PROJECT: City of Ferndale Cherry Street Sidewalk Project
(Schedule A and Schedule B) and Pioneer Park
Sidewalk Project (Schedule C)

ADDENDUM NO. 1
To the Contract Provisions for
CITY OF FERNDAL, WASHINGTON

Cherry Street Sidewalk Project, City Project No. ST2015-09 (Schedule A and Schedule B)
Pioneer Park Sidewalk Project, City Project No. PA2018-01 (Schedule C)

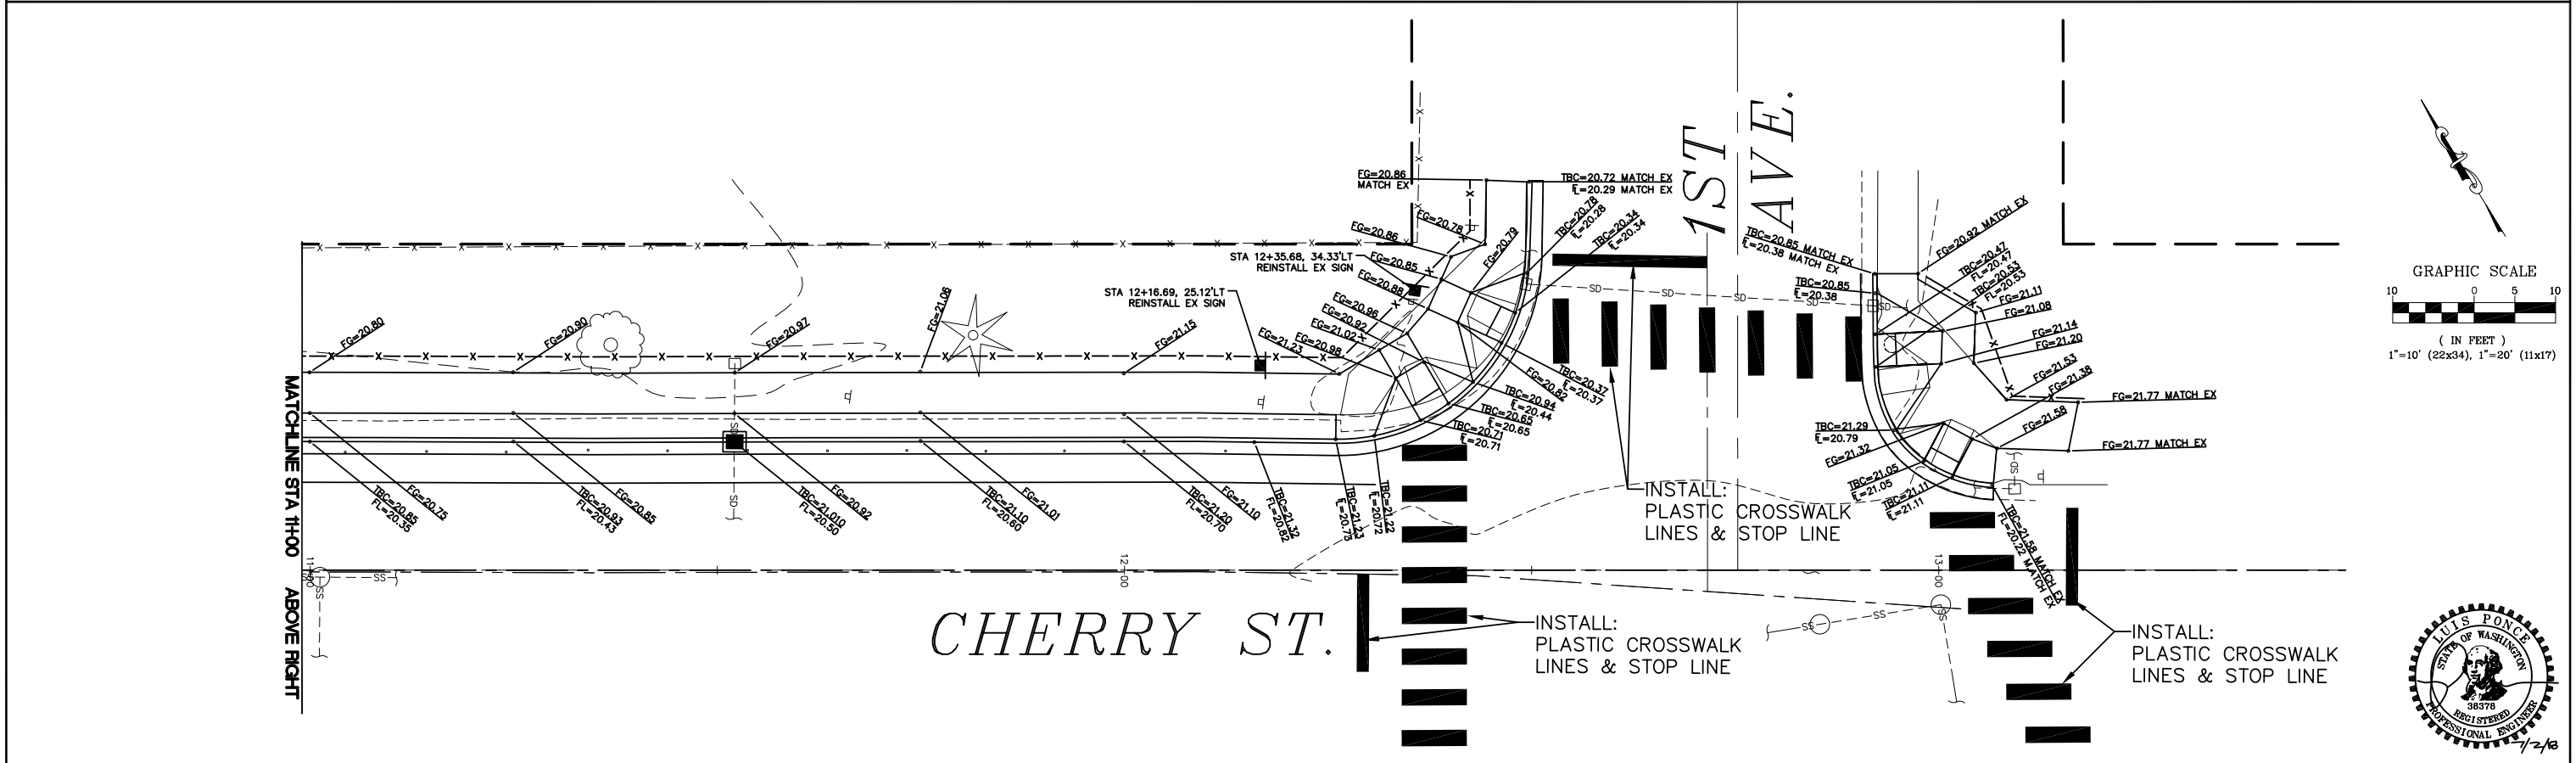
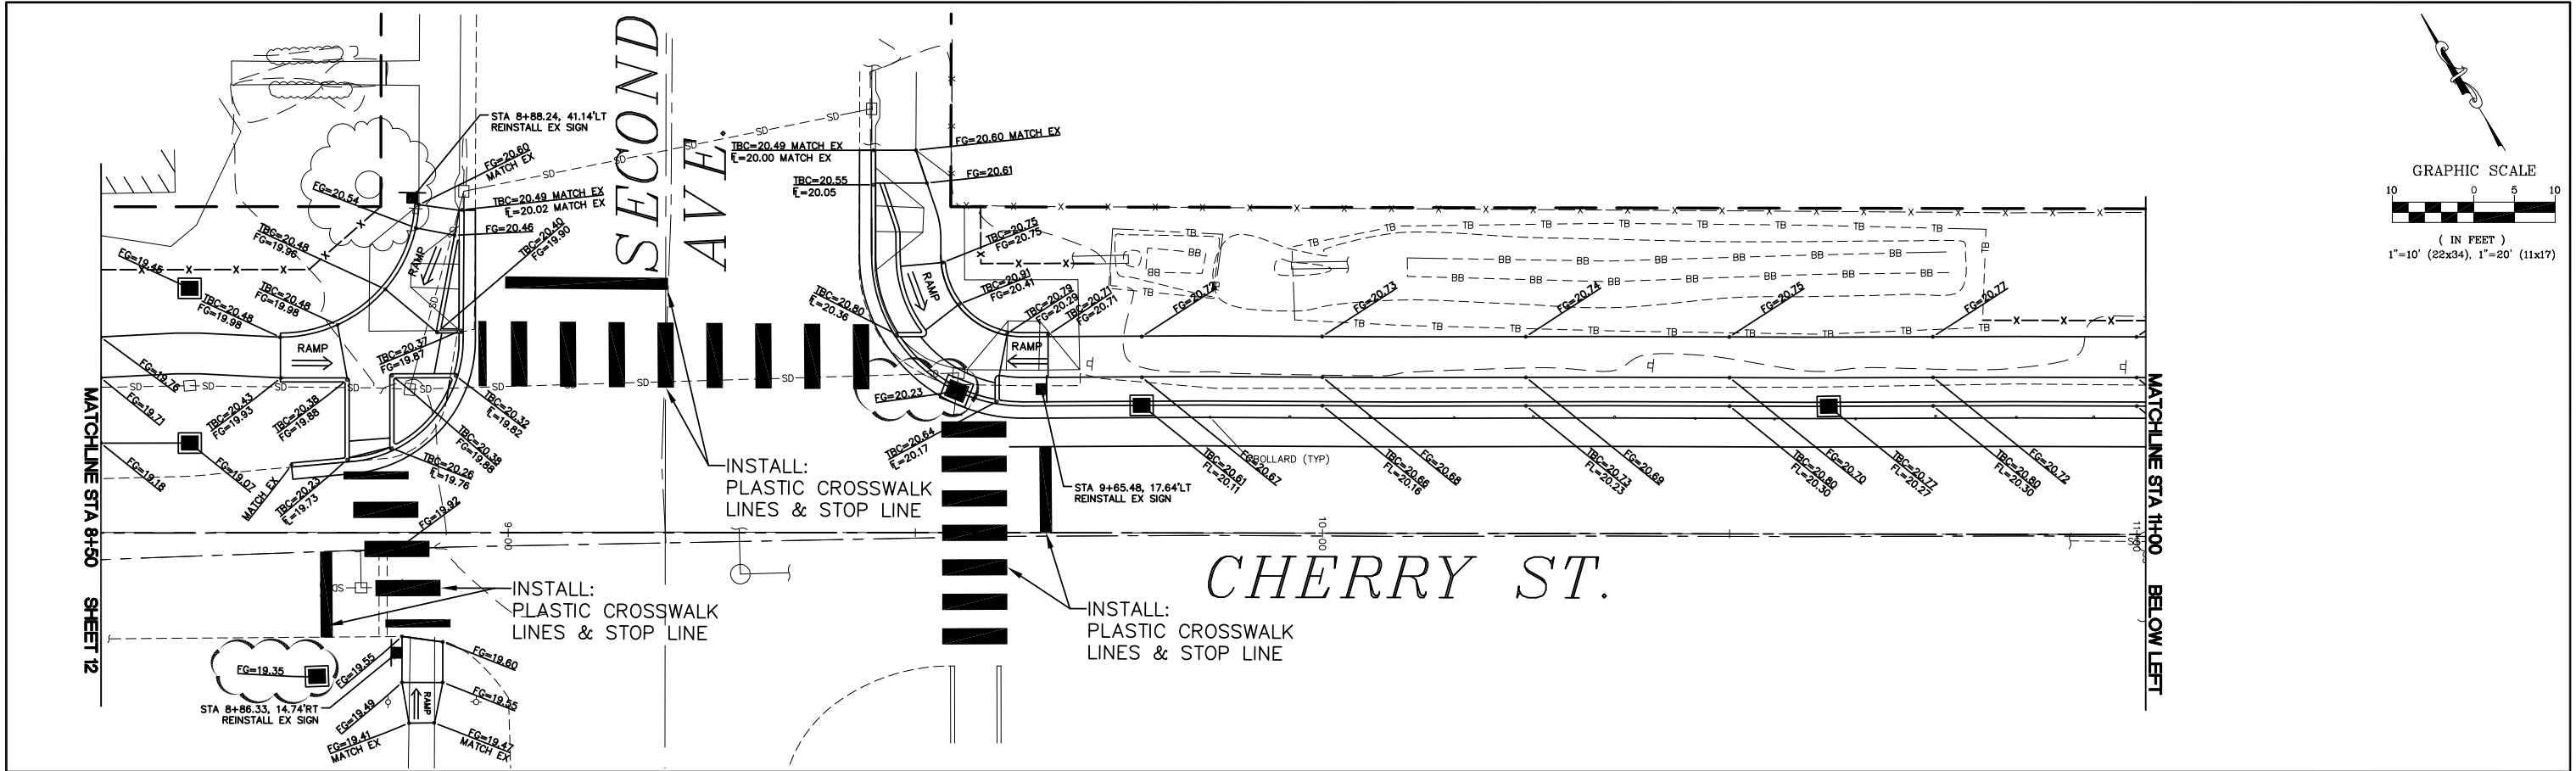
Schedule A and Schedule B, Plan Sheet 13

Grade information added at relocated catchbasin as shown.

DATE
7/2/2018
SHEET
3 of 7

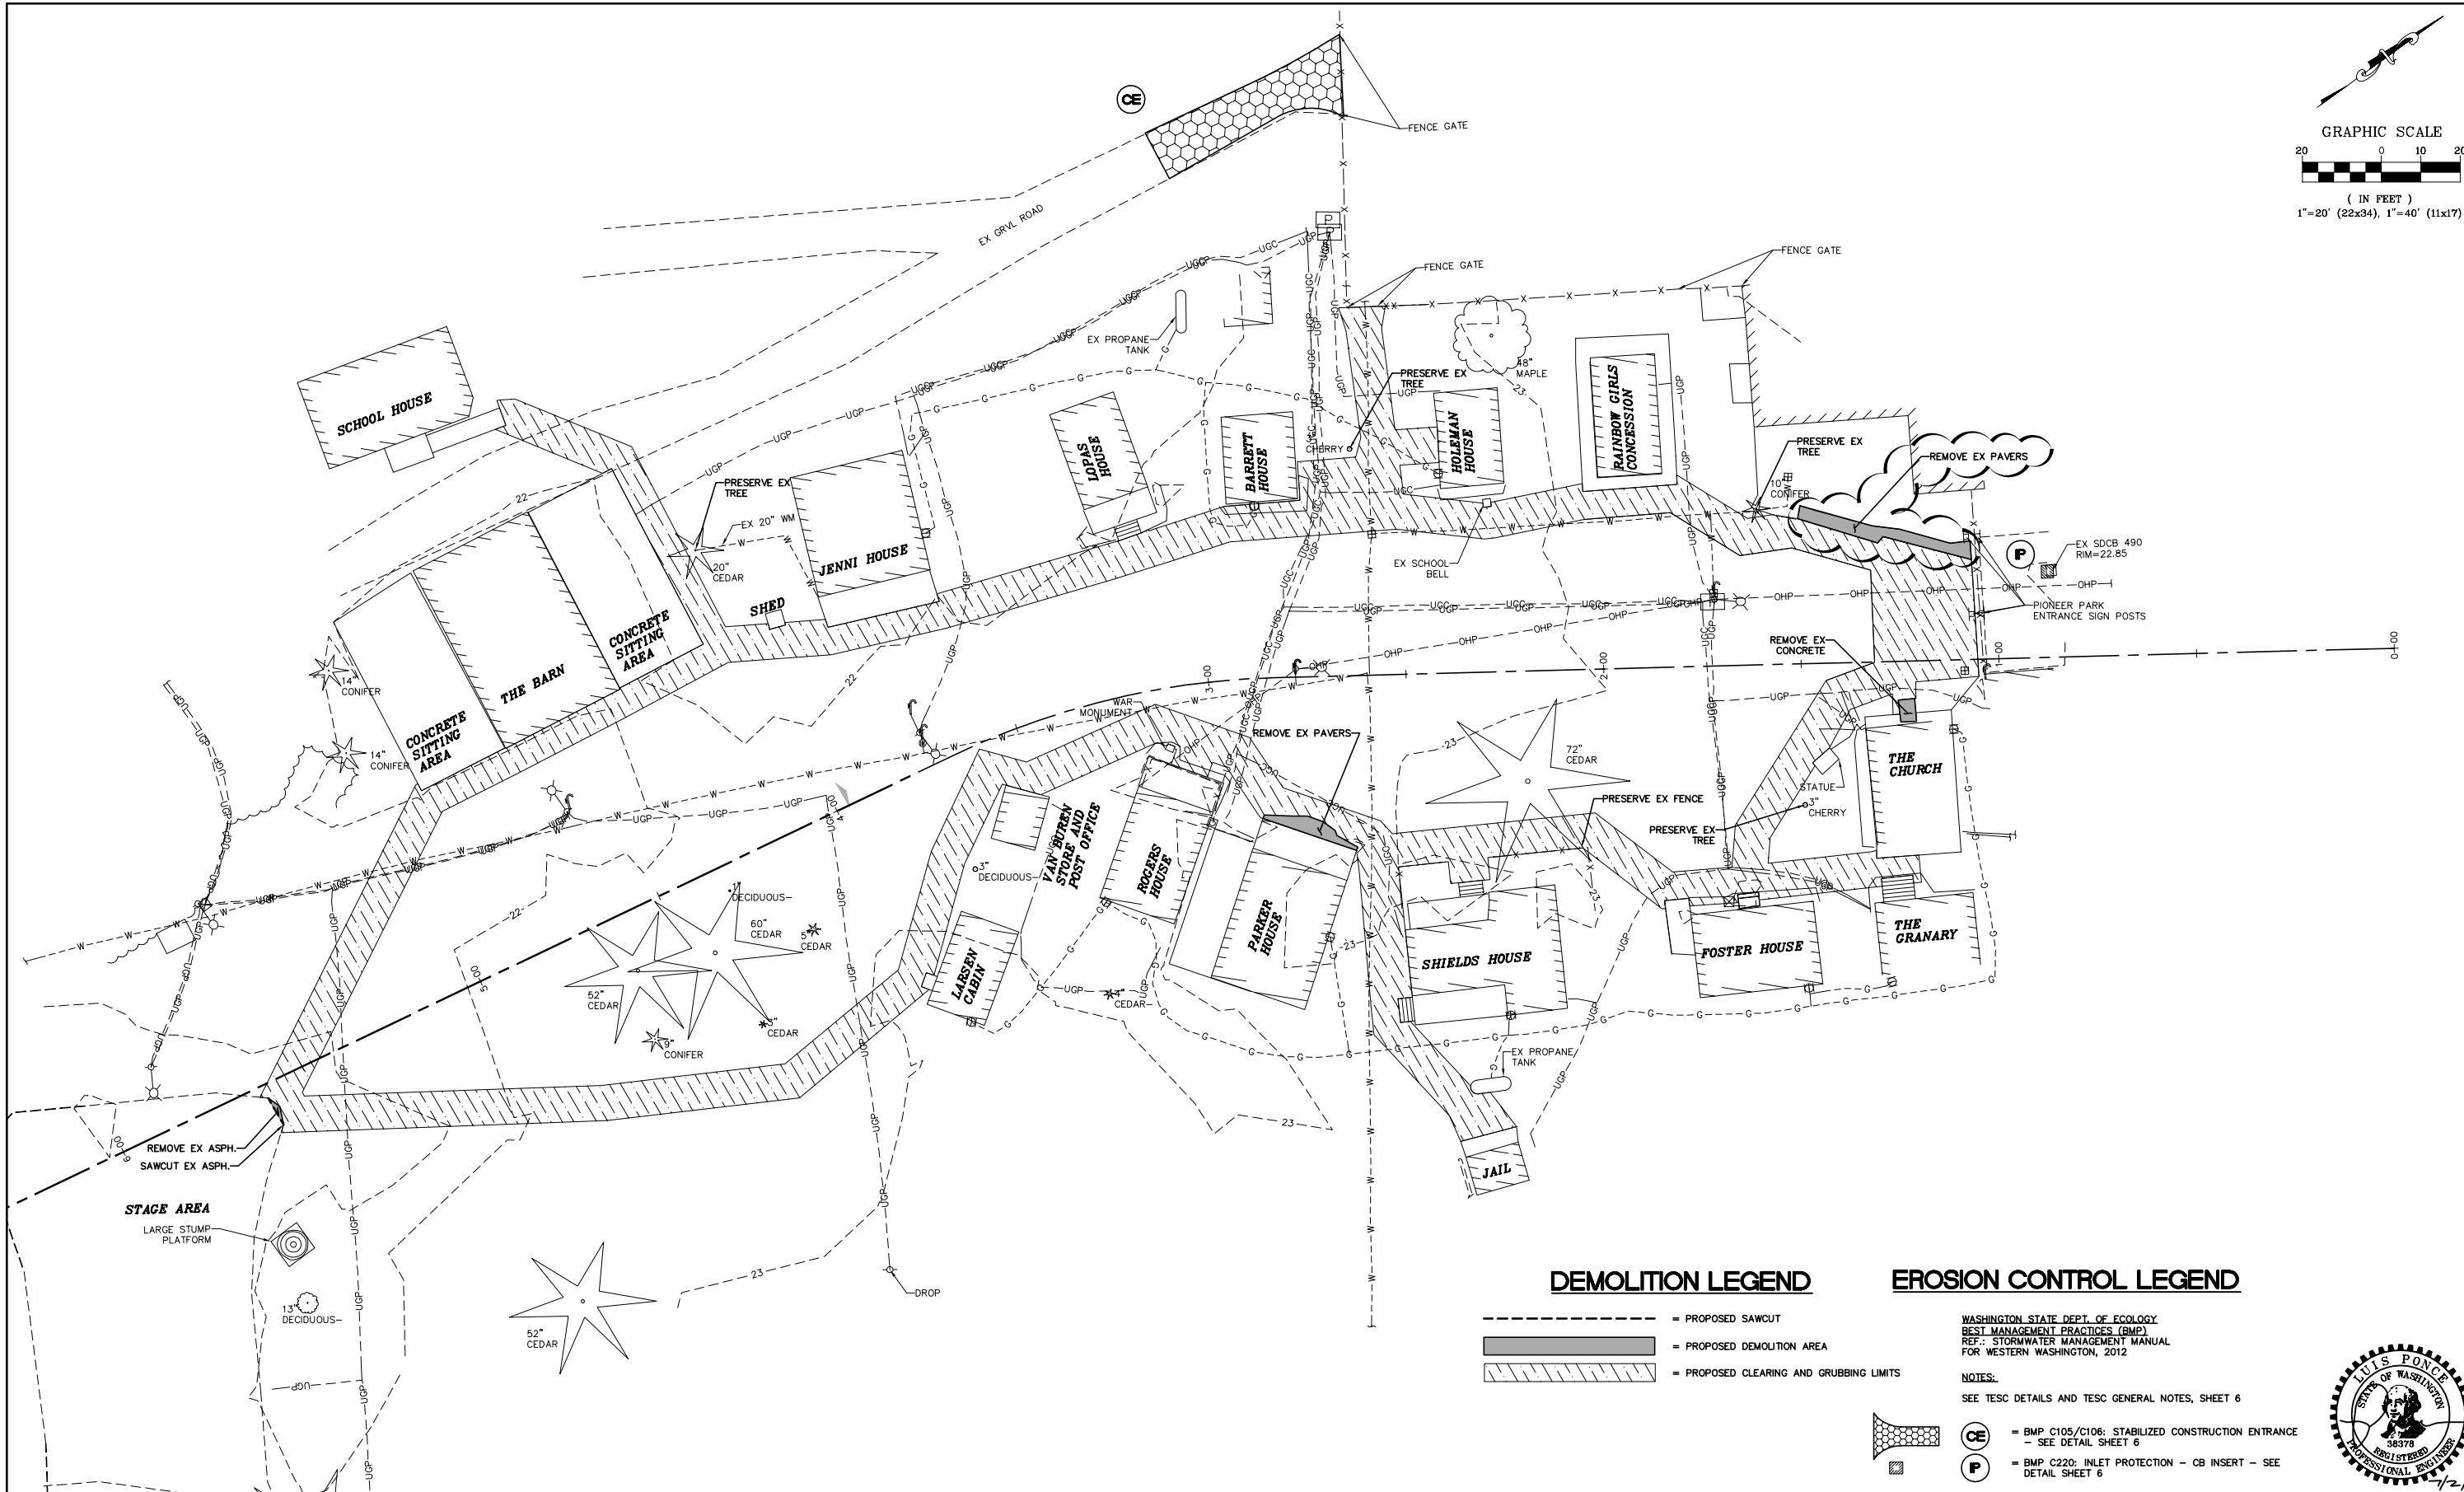
Schedule C, Plan Sheet 3

The removal of pavers between approximately STA 1+00 RT to STA 1+50 RT were added.

DATE **7/2/2018**
SHEET **4**
of **7**

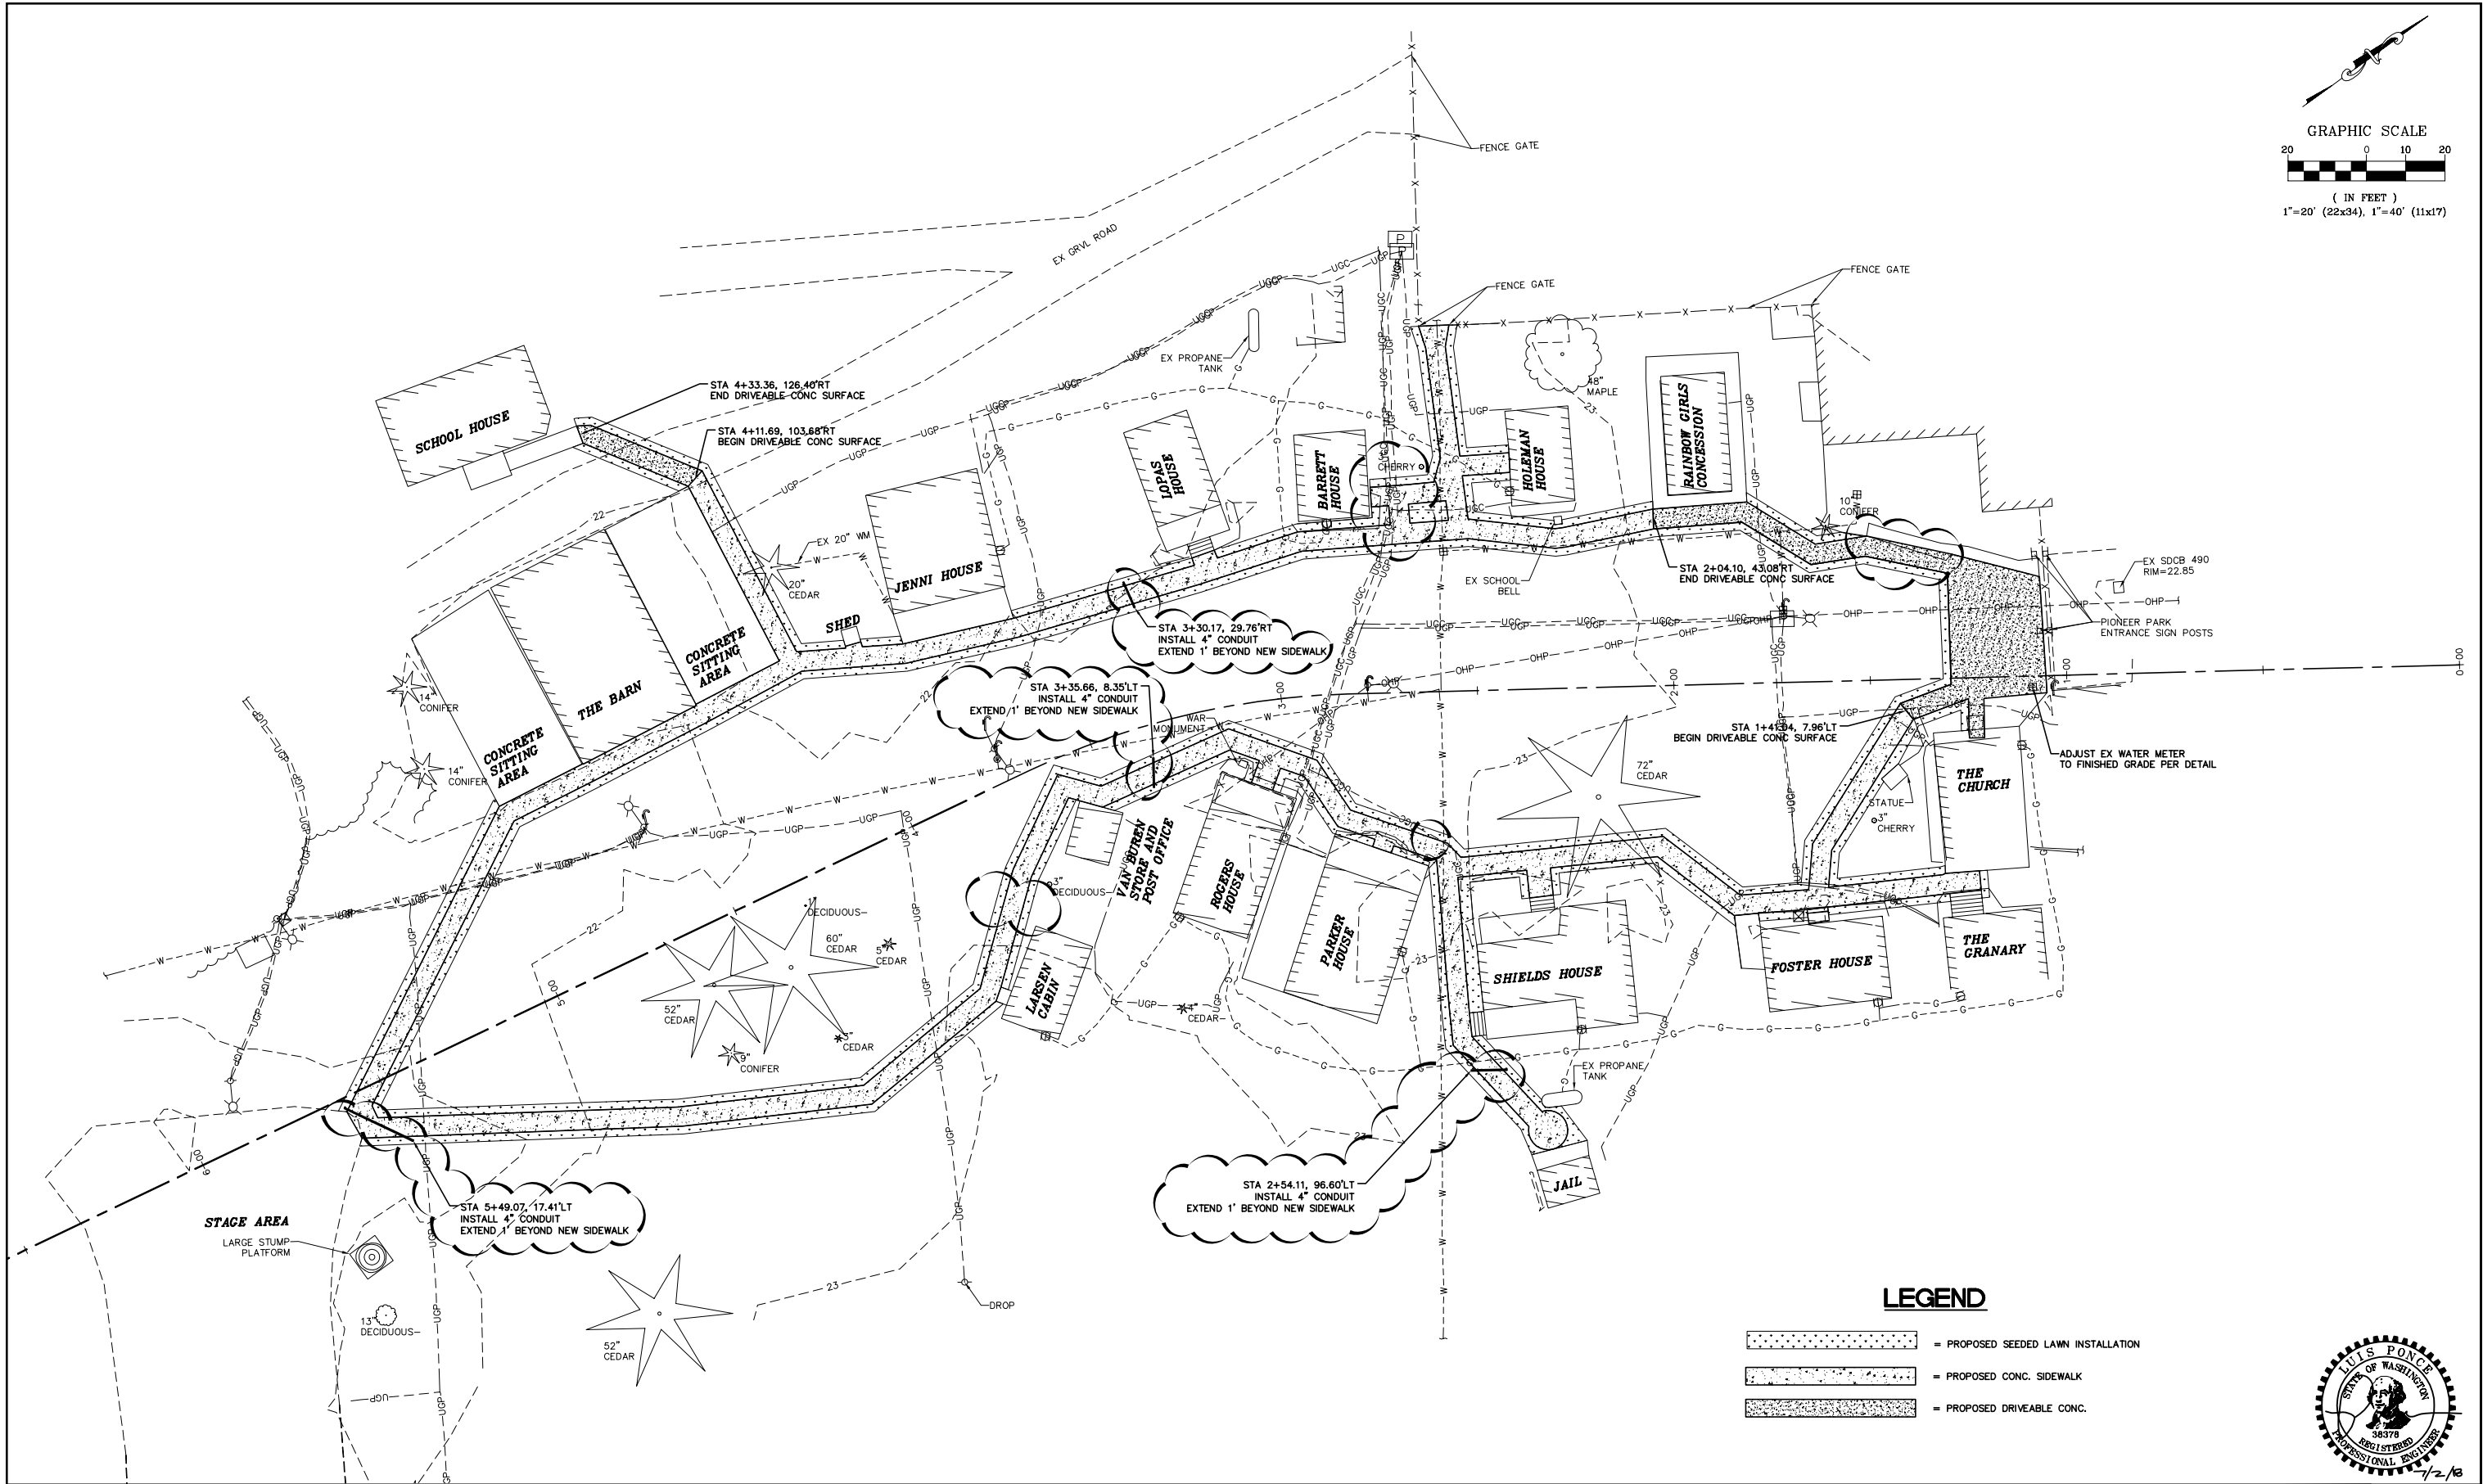
Schedule C, Plan Sheet 4

- The sidewalk layout between approximately STA 1+00 RT to STA 1+50 RT was revised.
- The conduit at approximately STA 2+60 RT, STA 2+60 LT, and STA 3+90 LT were removed.
- Conduit location were revised as shown.
